Agenda Item: 16.3 & 16.4

Source: Motorola

Title: Common transport channel management

Document for: Decision

2.1.1   ~~Downlink~~ Common Transport Channel Setup

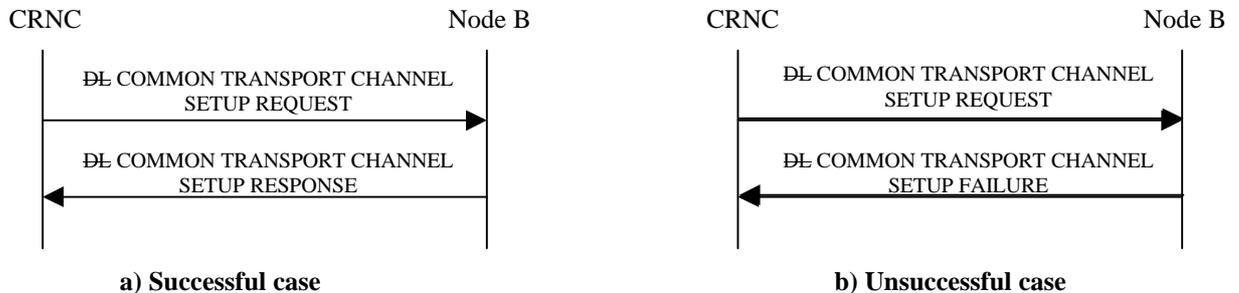
The RNC initiates a definition of ~~downlink~~ common transport channel in a cell within Node B, which defines the ordered channels and takes them into service. The result is communicated back to the RNC.

This NBAP common procedure is used by the CRNC to request Node B to support the following logical resources: FACH, PCH, BCH, <u>DSCH, and RACH.</u> This procedure is initiated by CRNC.

~~DL~~ COMMON TRANSPORT CHANNEL   ~~DL~~ COMMON TRANSPORT CHANNEL
SETUP REQUEST   SETUP REQUEST

~~DL~~ COMMON TRANSPORT CHANNEL   ~~DL~~ COMMON TRANSPORT CHANNEL
SETUP RESPONSE   SETUP FAILURE

2.1.2 ~~Downlink~~ Common Transport Channel Reconfigure

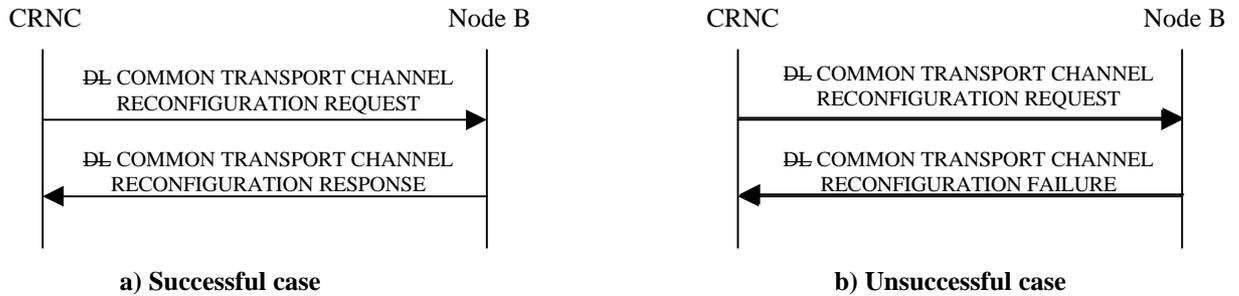
The RNC initiates a change of the configuration of ~~downlink~~ common transport channels in Node B, which reconfigures the channels. The result is communicated back to the RNC.

- The RNC shall use the following procedure to re-configure a ~~downlink~~ common transport channel

CRNC	Node B	CRNC	Node B
~~DL~~ COMMON TRANSPORT CHANNEL RECONFIGURATION REQUEST →		~~DL~~ COMMON TRANSPORT CHANNEL RECONFIGURATION REQUEST →	
← ~~DL~~ COMMON TRANSPORT CHANNEL RECONFIGURATION RESPONSE		← ~~DL~~ COMMON TRANSPORT CHANNEL RECONFIGURATION FAILURE	
a) Successful case		**b) Unsuccessful case**

2.1.3 ~~Downlink~~ Common Transport Channel Delete

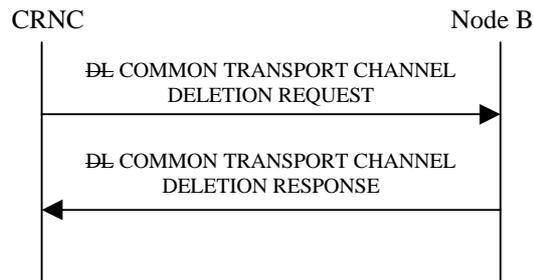
This NBAP common procedure is used by the Controlling RNC to request Node B to delete ~~Downlink~~ Common Transport Channels. This procedure is initiated by CRNC.

│   DL COMMON TRANSPORT CHANNEL   │
              │        DELETION REQUEST         │
              │────────────────────────────────▶│
              │                                 │
              │   DL COMMON TRANSPORT CHANNEL   │
              │        DELETION RESPONSE        │
              │◀────────────────────────────────│
              │                                 │
```

2.2.1 ~~Uplink Common Transport Channel Setup~~

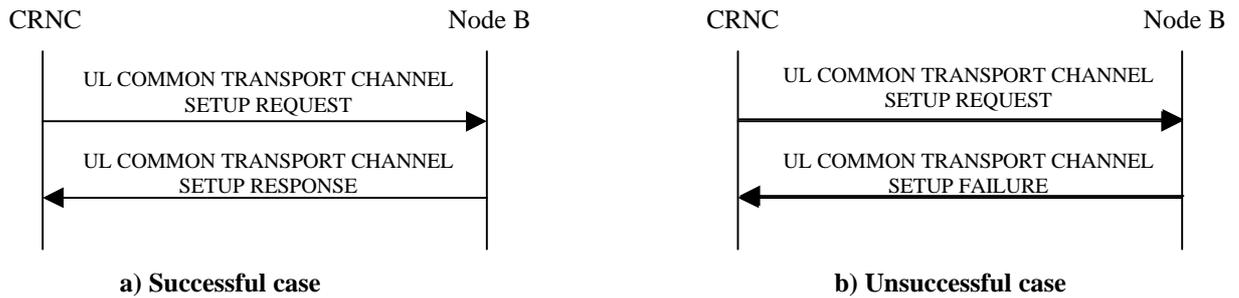
~~The RNC initiates a definition of uplink common transport channels in a cell within Node B, which defines the ordered channels and takes them into service. The result is communicated back to the RNC.~~

~~This NBAP common procedure is used by the Controlling RNC to request Node B to support the logical resources RACH. This procedure is initiated by CRNC.~~

2.2.2 Uplink Common Transport Channel Reconfigure

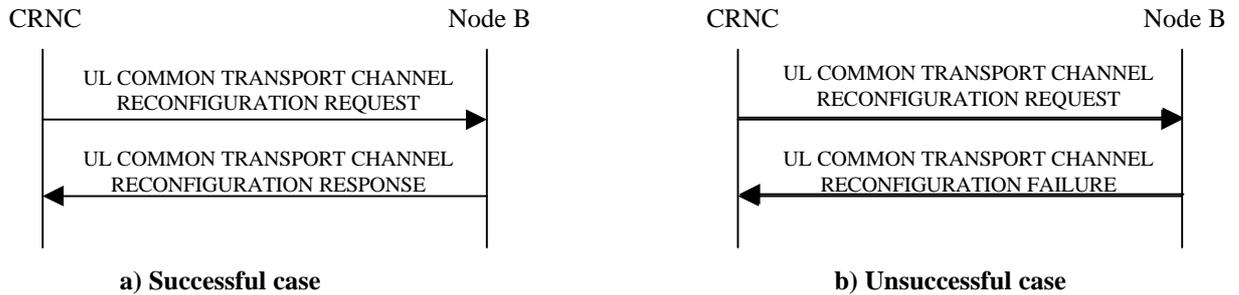
~~The RNC shall use the following procedure to re-configure an uplink common transport channel:~~

~~The UL COMMON TRANSPORT CHANNEL RECONFIGURATION REQUEST message contains the following information:~~
- ~~Cell Id (allows the Node B to reference the channel against the correct cell where a Node B supports multiple cells)~~
- ~~Common channel type (e.g. FACH,) and identifier (for the case where more than one common transport channel of the same type exists in a cell)~~
- ~~New UL radio resource (UL channelisation code, frequency)~~
- ~~Transaction Id (identifies the procedure)~~

~~2.2.3 Uplink Common Transport Channel Delete~~

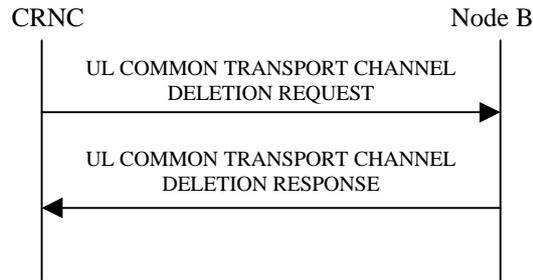
~~The RNC initiates the deletion of uplink common transport channel(s) in a cell within Node B, which deletes the requested channels. The result is communicated back to the RNC.~~

~~This NBAP common procedure is used by the Controlling RNC to request Node B to delete the logical resource RACH. This procedure is initiated by CRNC.~~
